CITY OF NEWARK

Contract No. 24-14

Addendum #1

OLD PAPER MILL ROAD
PARK

L-111

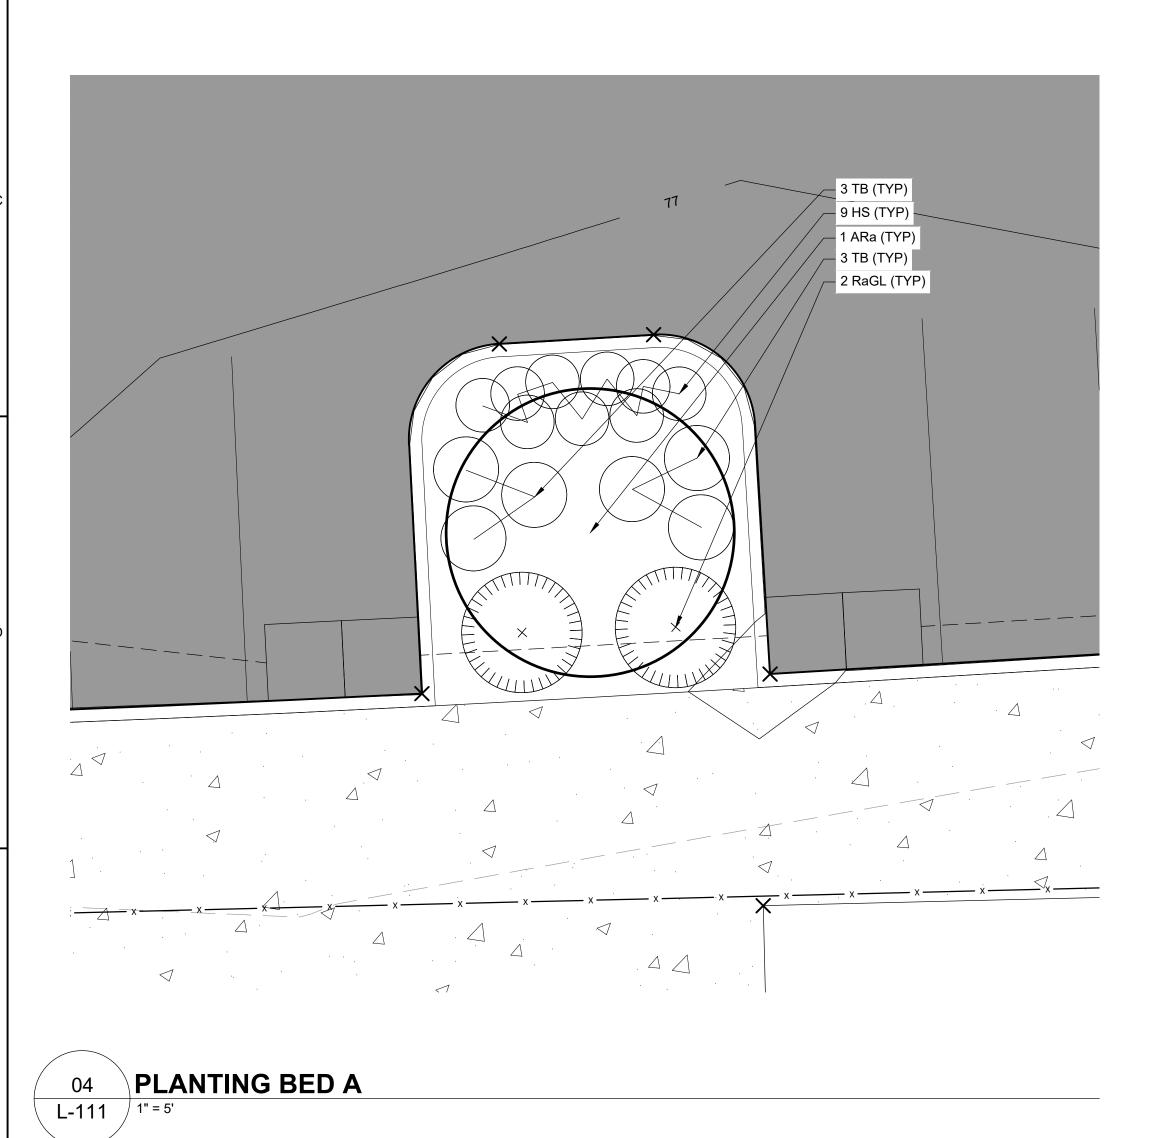
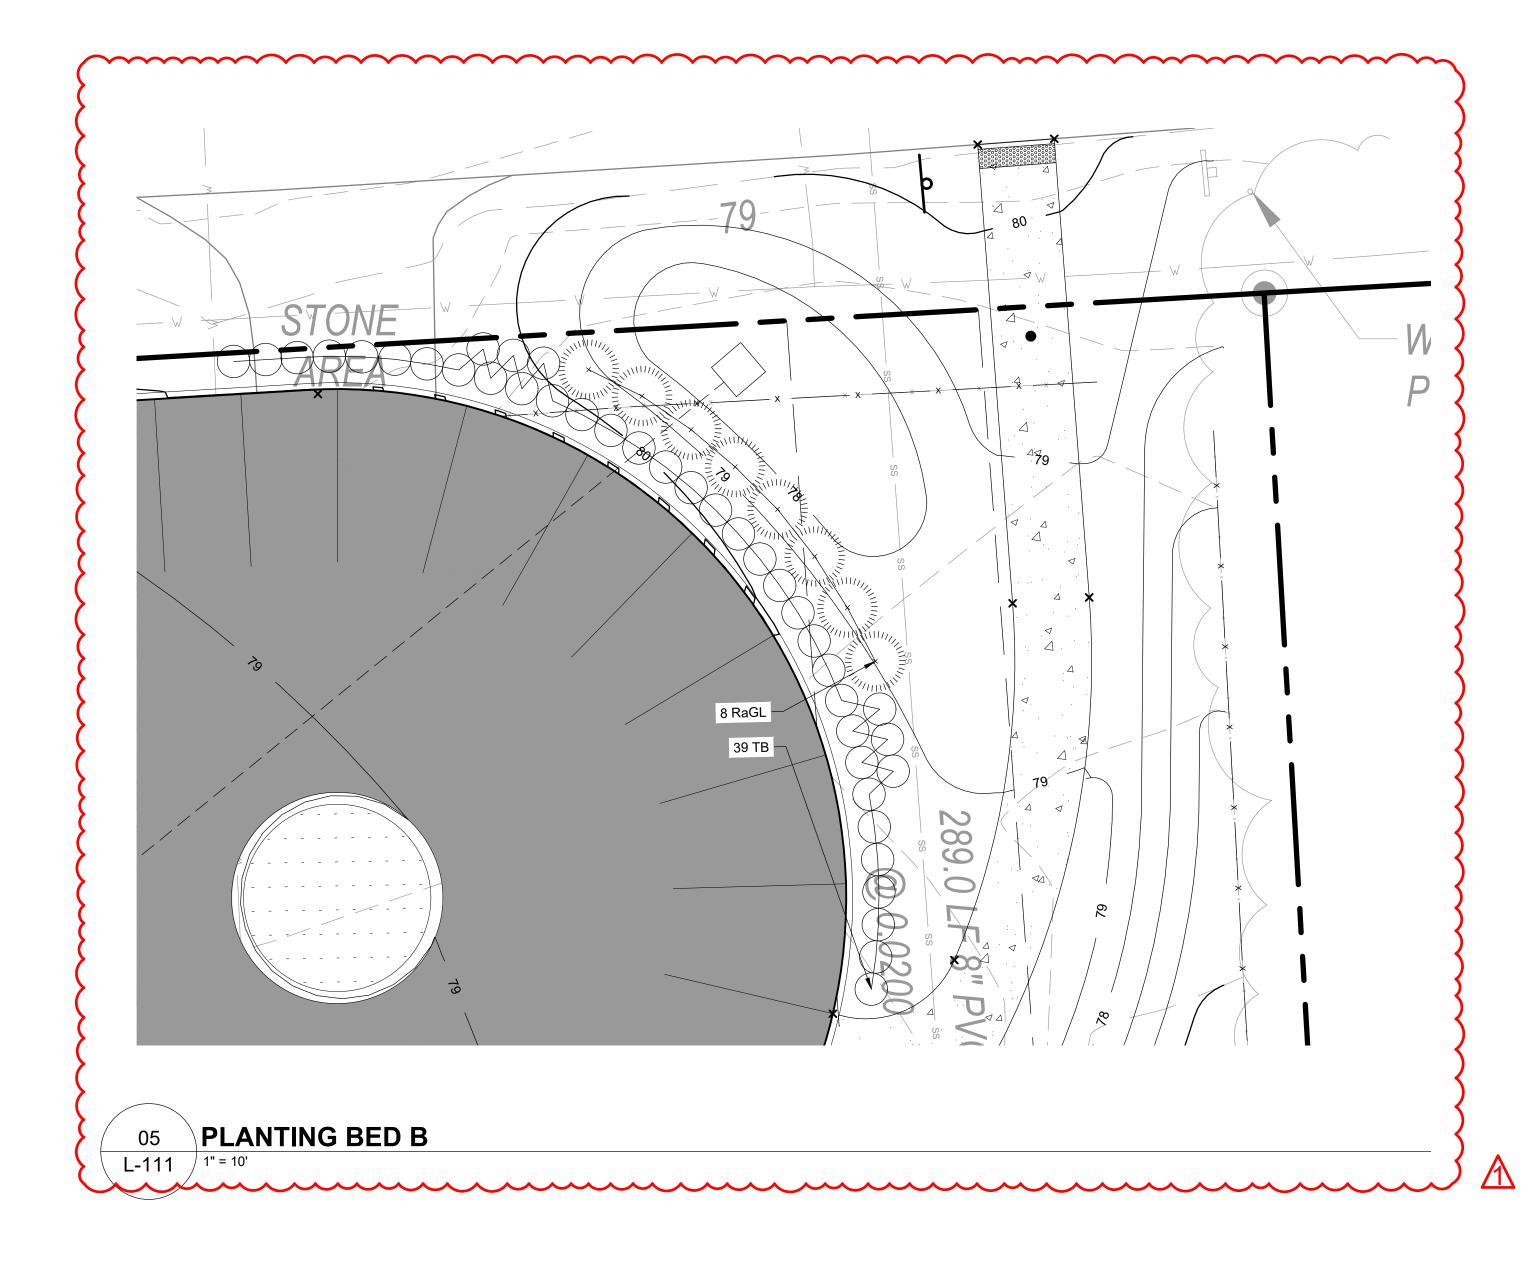
RE	REVISIONS								
	NO.									
	1	10/14/24	ADDENDUM 1
